I, the undersigned hereby certify that this topography, indicated by 1' contours and elevations shown hereon represent an actual field survey made by me on Aug. 19, 1991 and that the elevations were taken at appropriate intervals and that as of that date they existed as indicated hereon.
Thomas M. Coffman PS #6857
SITE PLAN
FOR
TOM HURST
BEING PART OF LOT No. 18, TRACT 4; TOWNSHIP OF PAINESVILLE, COUNTY OF LAKE, STATE OF OHIO.
EXIST. PROP.
EXIST. PROP.
N
SCALE: 1" = 20'
STORM DRAINAGE EASE.
10'

THOMAS P. GILLES, P.E.
Lake County Engineer
By GJH Date 9/27/91
JAN. 19, '90
REV 2-2-90
9-14-91
SEWAGE DISPOSAL PERMIT MUST BE OBTAINED BY A LAKE COUNTY LICENSED INSTALLER BEFORE INSTALLATION IS STARTED.
Reviewed and Accepted
LAKE COUNTY GENERAL HEALTH DISTRICT
Date 9.26.91
No permit issued until copy of easement provided
JOEL LUCIA, R. S., M. P. H.
Health Commissioner
BY Nancy Nelson
LOW YIELD WATER FIXTURES REQUIRED ON ALL:
Shower Head
Toilet
VILLAGE SURVEYING CO.
202 THIRD ST. FAIRPORT HBR., OH 44077

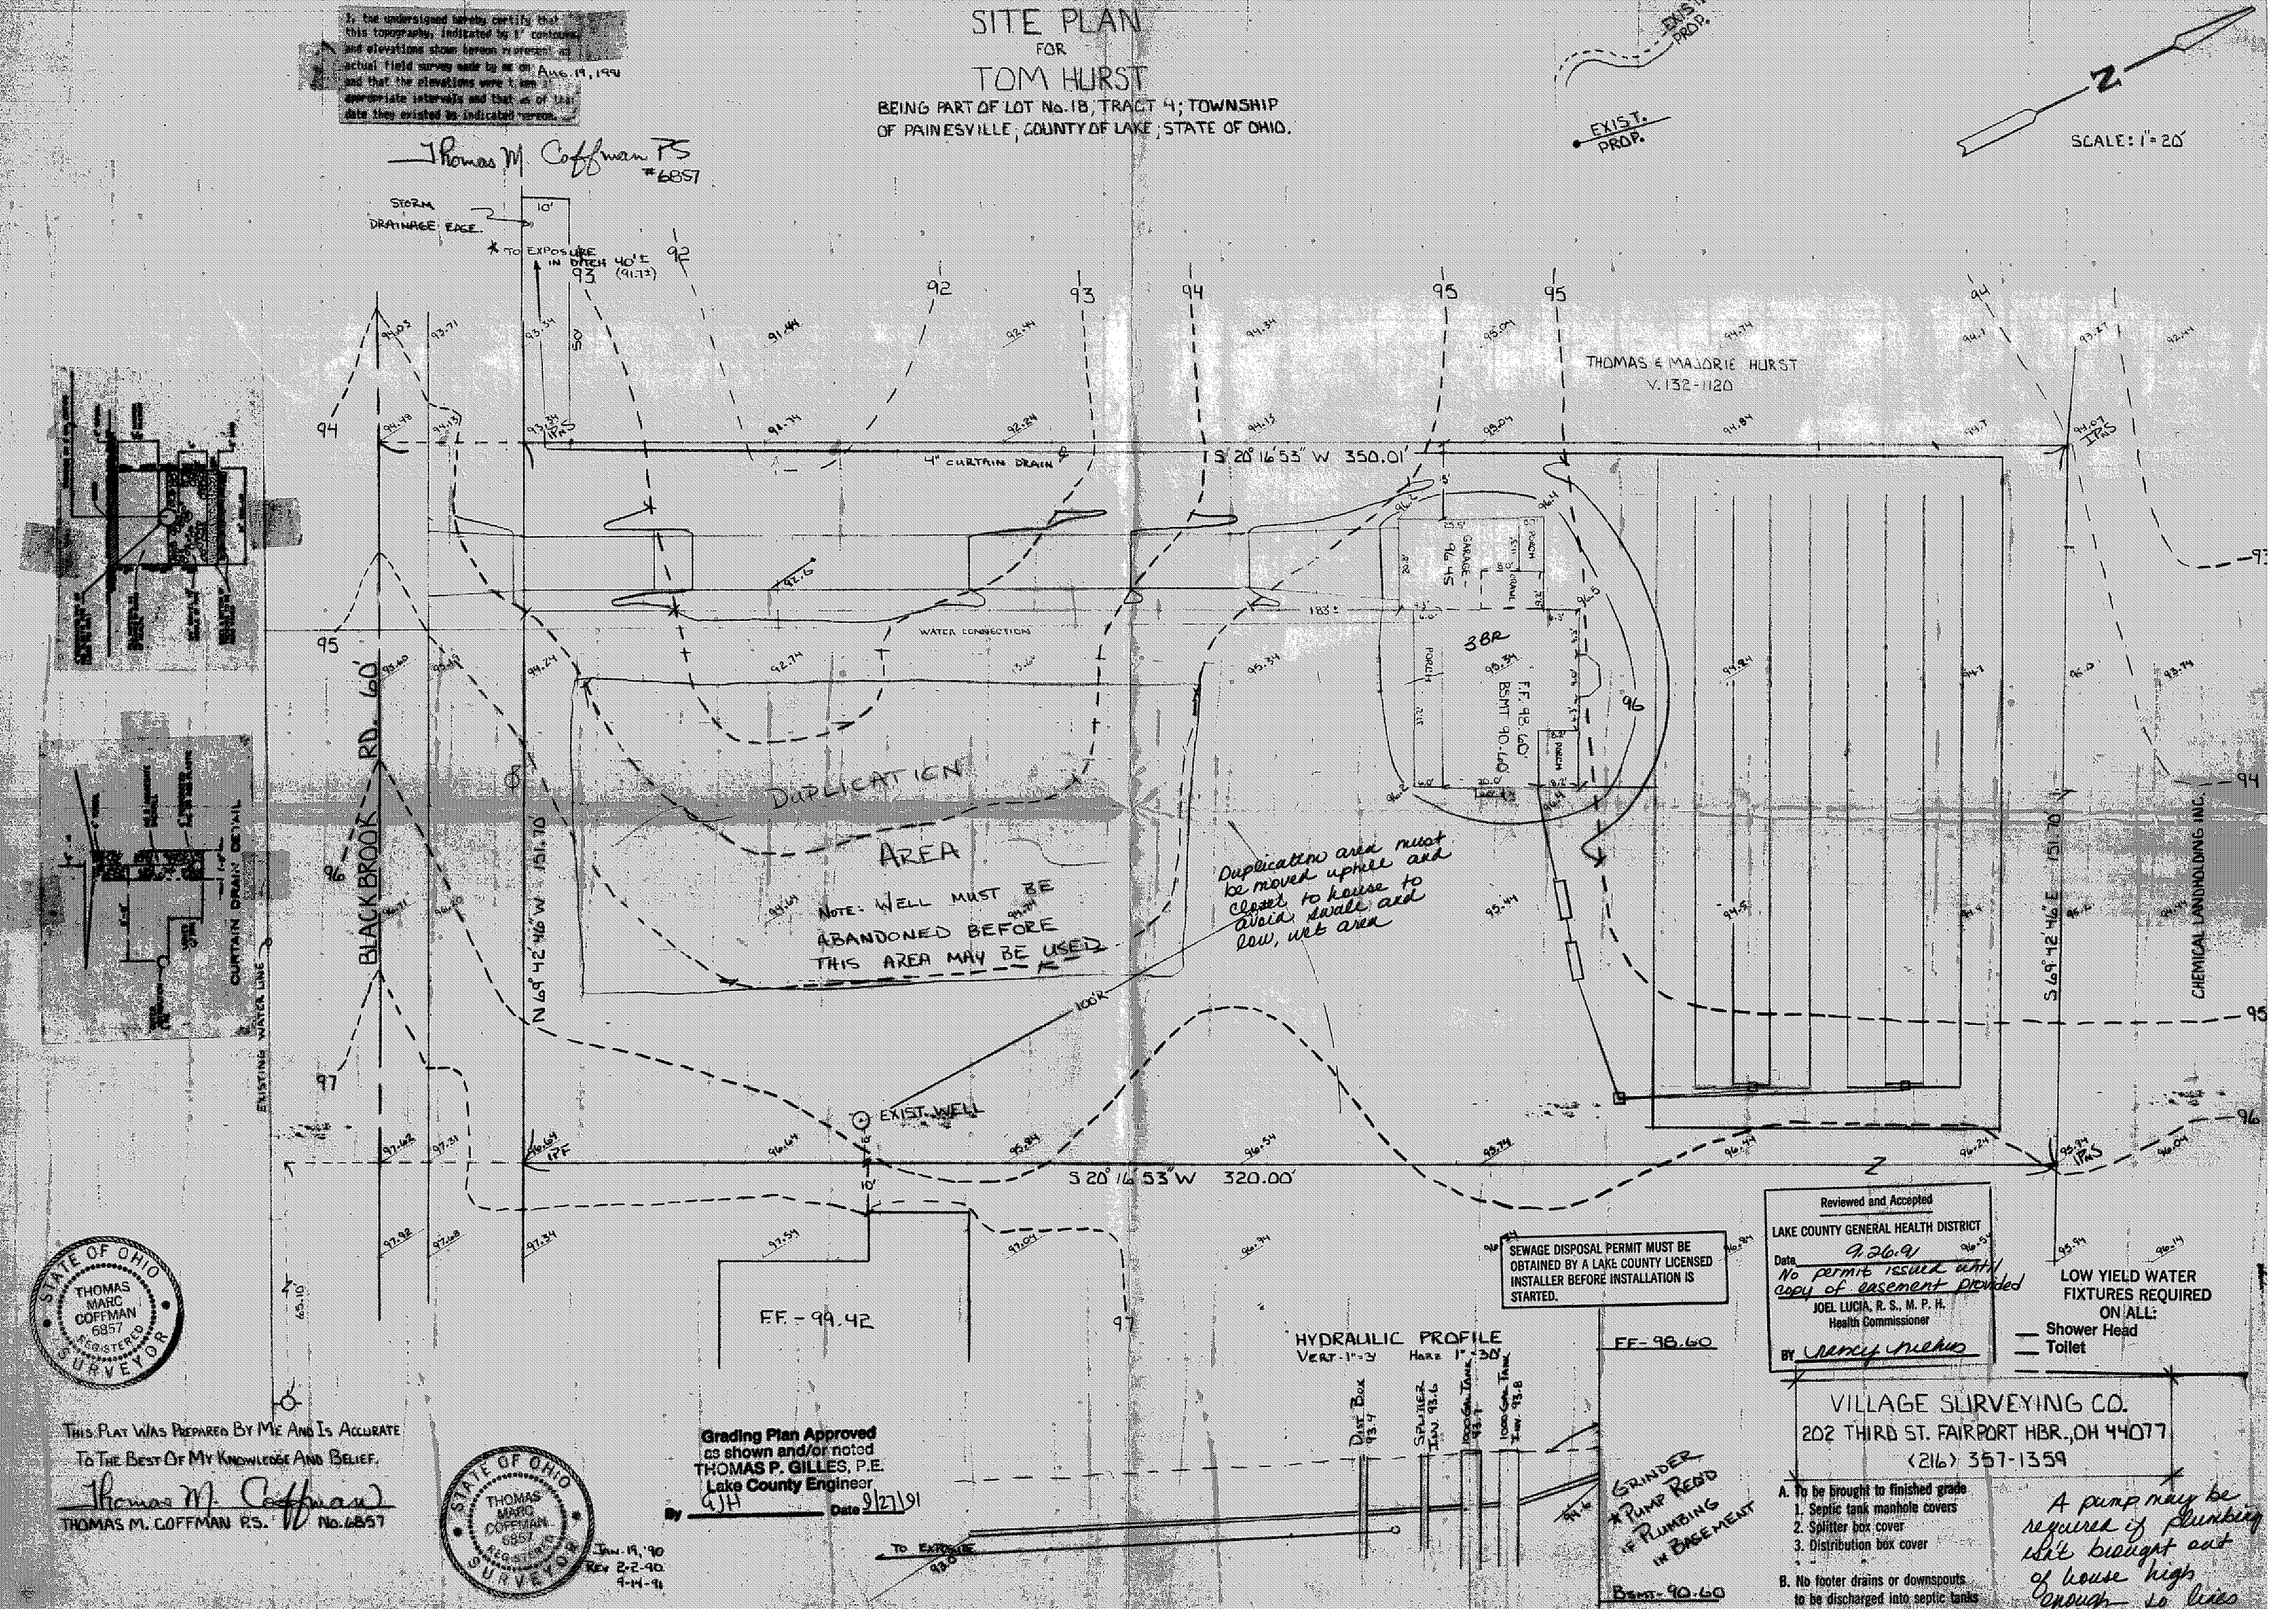
* TO EXPOSURE IN DITCH 40'± (91.7±)
THOMAS & MAJORIE HURST
V. 132-1120
4" CURTAIN DRAIN
S 20° 16' 53" W 350.01'
WATER CONNECTION
GARAGE - 96.45
PORCH
3BR
F.F. 98.60'
BSMT 90.60'
DUPLICATION AREA
NOTE: WELL MUST BE ABANDONED BEFORE THIS AREA MAY BE USED
Duplication area must be moved uphill and closer to house to avoid swale and low, wet area
BLACKBROOK RD. 60'
N 69° 42' 46" W 151.70'
S 69° 42' 46" E 151.70'
CHEMICAL LANDHOLDING INC.
EXISTING WATER LINE
CURTAIN DRAIN DETAIL
EXIST. WELL
S 20° 16' 53" W 320.00'
F.F. - 99.42
HYDRAULIC PROFILE
VERT. 1" = 3'
HORZ. 1" = 30'
DIST. BOX 93.4
SPLITTER INV. 93.6
1000 GAL. TANK 93.7
1000 GAL. TANK INV. 93.8
FF - 98.60
BSMT - 90.60
GRINDER * PUMP REQ'D IF PLUMBING IN BASEMENT
TO EXPOSURE 93.0
STATE OF OHIO THOMAS MARC COFFMAN 6857 REGISTERED SURVEYOR
THIS PLAT WAS PREPARED BY ME AND IS ACCURATE TO THE BEST OF MY KNOWLEDGE AND BELIEF.
Thomas M. Coffman
THOMAS M. COFFMAN P.S. No. 6857
Grading Plan Approved as shown and/or noted

(216) 357-1359
A. To be brought to finished grade
1. Septic tank manhole covers
2. Splitter box cover
3. Distribution box cover
B. No footer drains or downspouts to be discharged into septic tanks
A pump may be required if plumbing isn't brought out of house high enough to lines
